SUBJECT: Forwards LC McCoy comments on K Mellon 801218 ltr re "Natl Register Assessment Program of Cultural Resources of 230kv Transmission Line Rights-of-Way from San Onofre Nuclear Station to Black Star Canyon & Santiago Substation."

Subject: Docket Nos. 50-361 and 50-362
San Onofre Nuclear Generating Station
Units 2 and 3

ARCHAEOLOGICAL REQUIREMENTS AND
DETERMINATION OF MANAGEMENT PLAN
FOR SAN ONOFRE NUCLEAR GENERATING
STATION, UNITS #2 AND #3

SDI-6138 (Map 24)

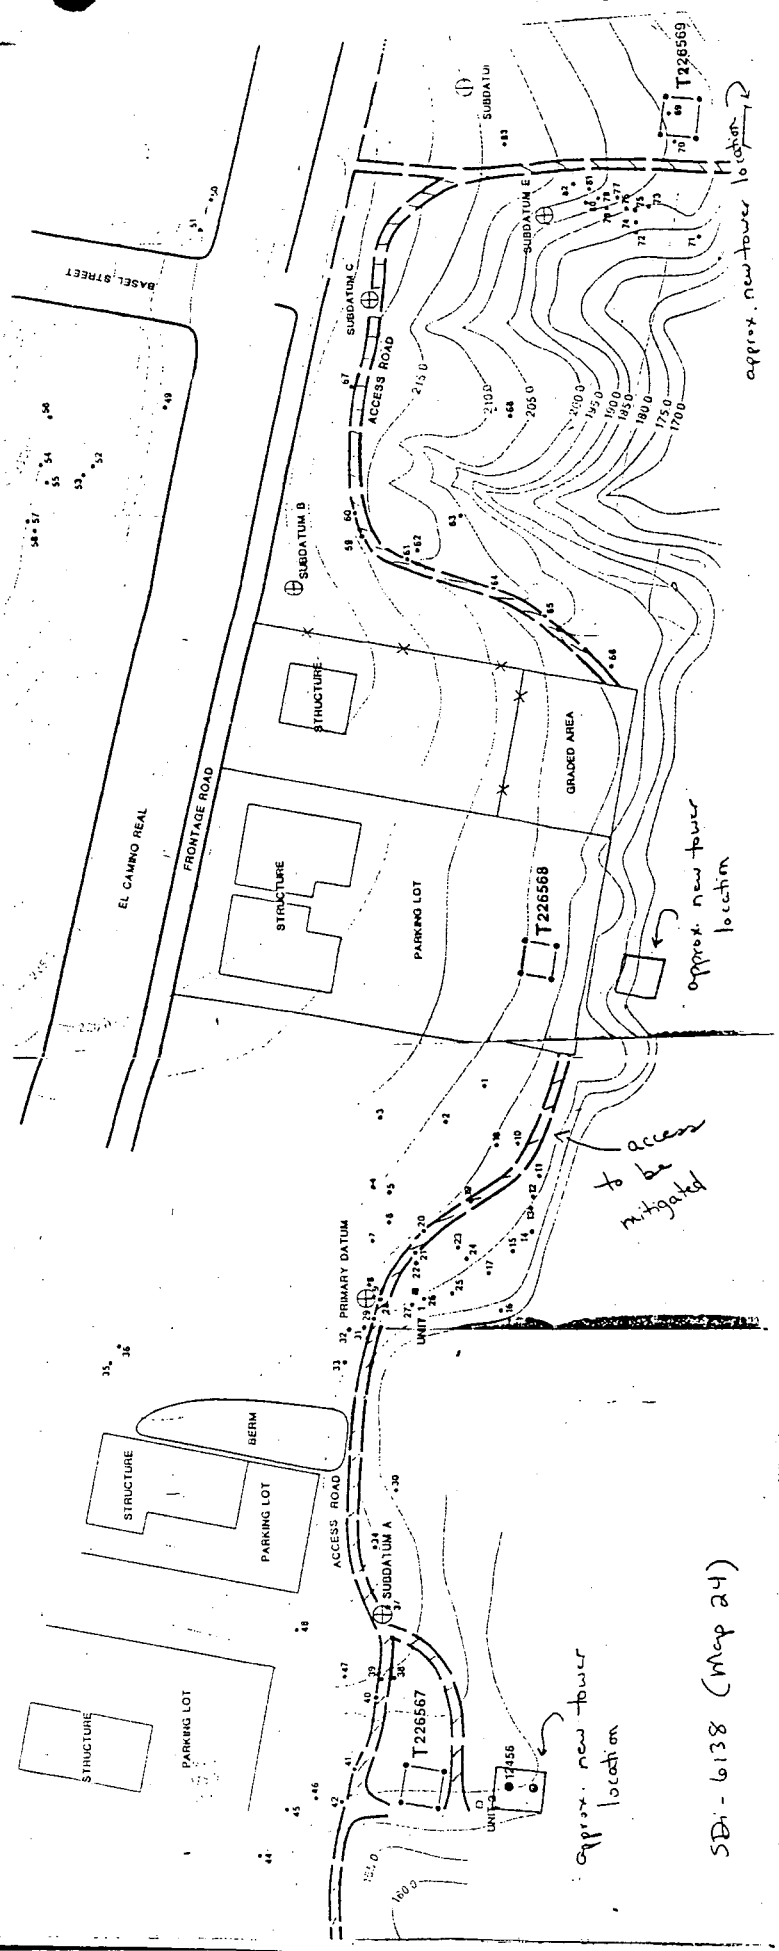
SDi-6138

Three new towers are proposed. All new steel lattice towers will be replacing existing structures (see attached map). One proposed tower location was tested during current assessment for subsurface cultural remains. Excavation results were negative (Unit 2). The other two new tower locations are beyond archaeological site boundaries. Therefore, the lack of any adverse effects to cultural remains by construction effects precludes the necessity of mitigation.

Access to the new tower location at CA-SDi-6138 will be restricted to an existing road with no cultural remains in evidence and beyond site boundaries.

SD-6140 (Map 25)

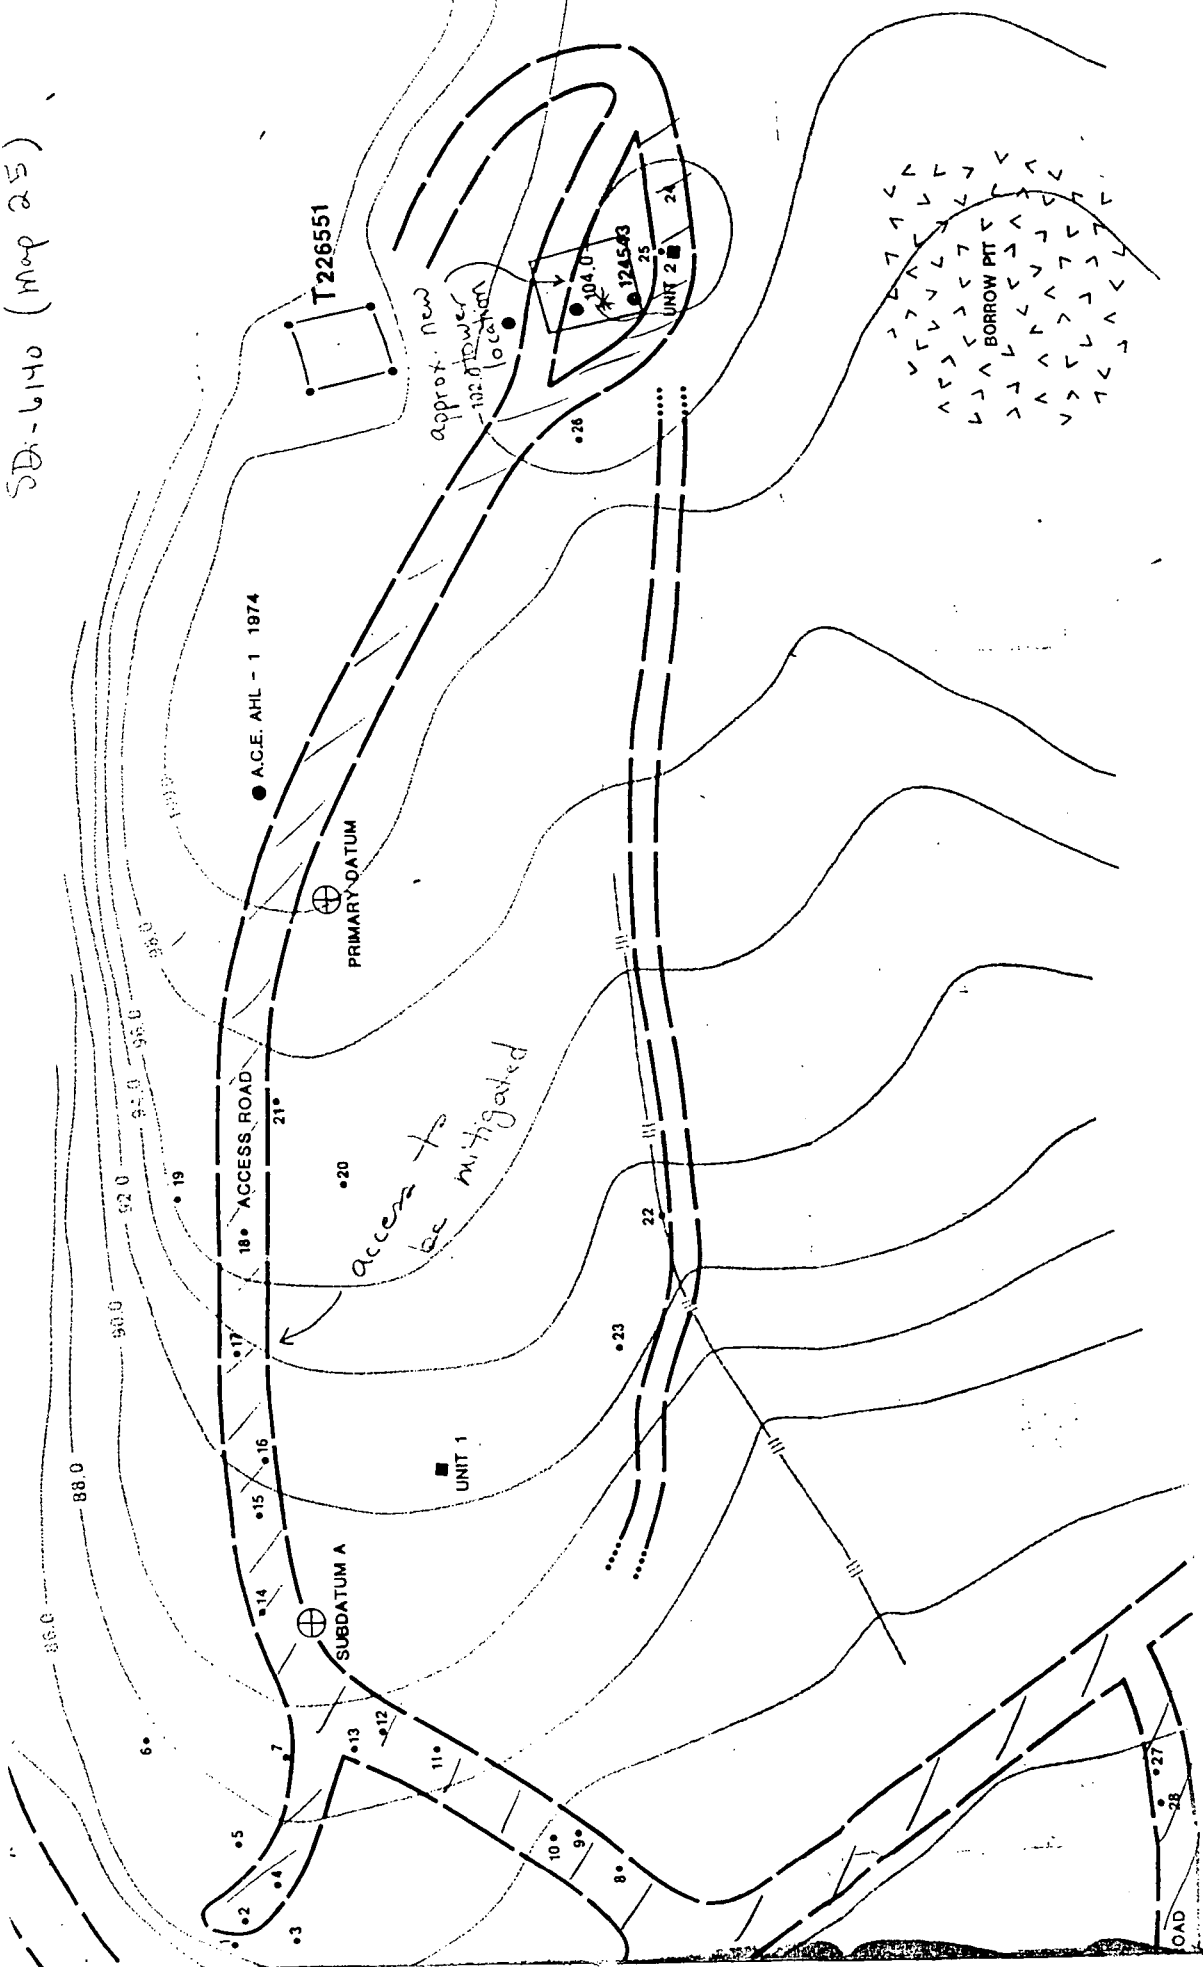
CA-SDi-6140

One new steel lattice tower is proposed. The new tower location will be approximately 80 feet to the northeast of an existing three-pole wooden structure. The area of the proposed new tower was tested for subsurface cultural remains during the current assessment. Excavation results were negative (Unit 2). Proposed construction activities at this site will not cause any adverse effects to cultural resources.

CA-SDi-6135

One new steel lattice tower is proposed. The new tower location will be approximately 80 feet directly to the east of the existing structure (226549) within an existing access road and road cut area (see attached map). Proposed construction activities at this site will not cause adverse effects to any cultural resources. Therefore, no program is necessary to mitigate construction effects.

SDI-6149 (Map 28)

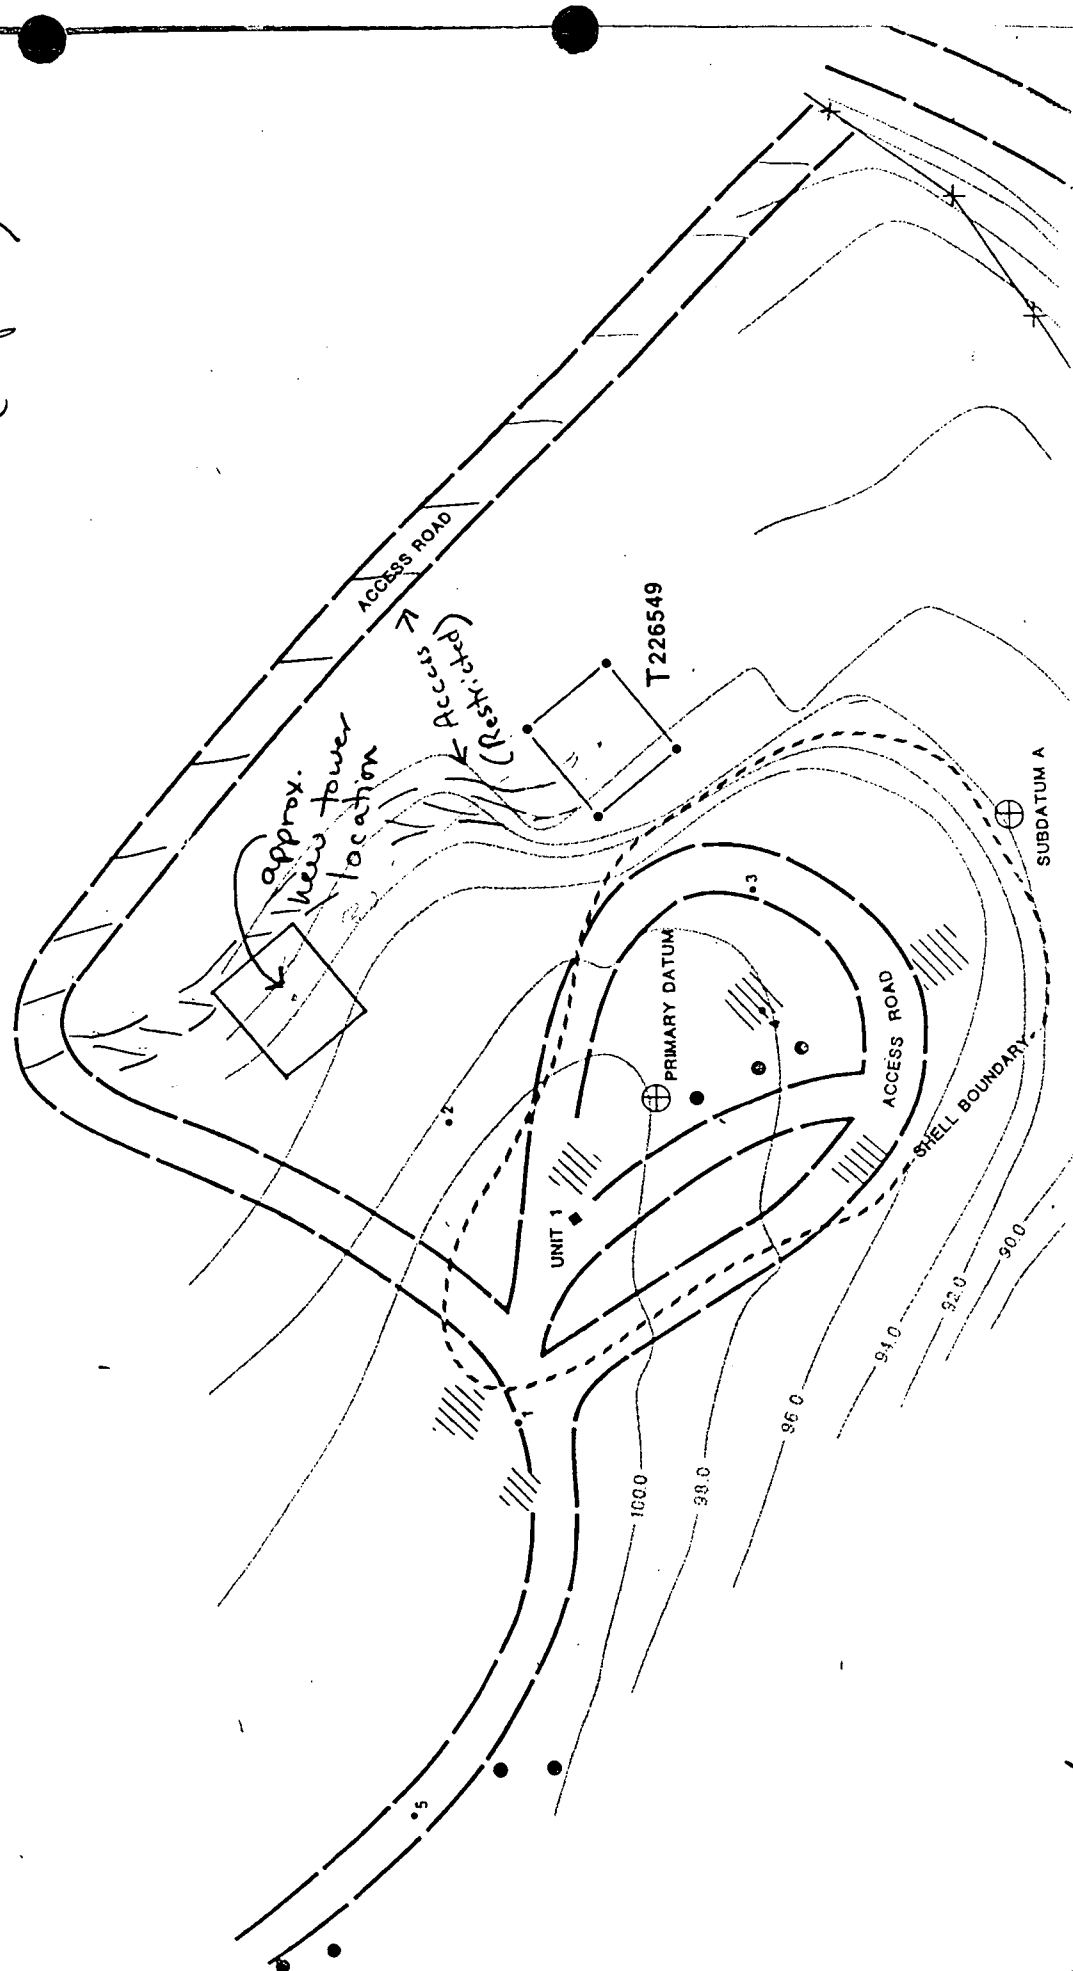
CA-SDi-6149

Previous assessment at this archaeological site mistakenly identified construction of a proposed new steel lattice tower as being a potential adverse impact to cultural resources. However, no new tower is proposed and although pulling operations are scheduled on an existing access road, this area is clear of site cultural remains (see attached map).

The lack of any potential construction impacts precludes the necessity of mitigation.
